**Town of Randolph
North Randolph Fire Station**

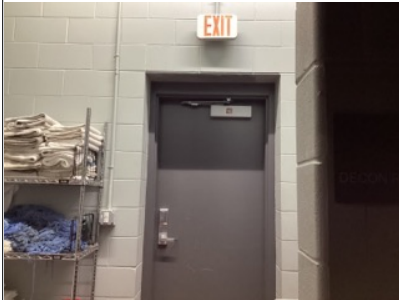
ID	Location	Floor	Room	Element	Type	Photo	Issues	Current Measure	Recommendations	Quantity	Price	Cost Estimation
Approach and Entrance												
Emergency Exit												
1	East Accessible Egress in Apparatus Room	1		Emergency Exit	N/A		Tactile sign not provided at exit Illuminated Int. Symbol of Acc. not provided (MAAB 2006)	- -	Provide tactile exit signs with raised characters and braille at exit doors. Mount signs between 48"- 60" above the finished floor located on the latch side of the door. Provide an illuminated sign with the International Symbol of Accessibility (ISA).	1	432	\$432
2	West Accessible Egress in Laundry Room Next to Apparatus Room	1		Emergency Exit	N/A		Tactile sign not provided at exit Illuminated Int. Symbol of Acc. not provided (MAAB 2006)	- -	Provide tactile exit signs with raised characters and braille at exit doors. Mount signs between 48"- 60" above the finished floor located on the latch side of the door. Provide an illuminated sign with the International Symbol of Accessibility (ISA).	1	432	\$432
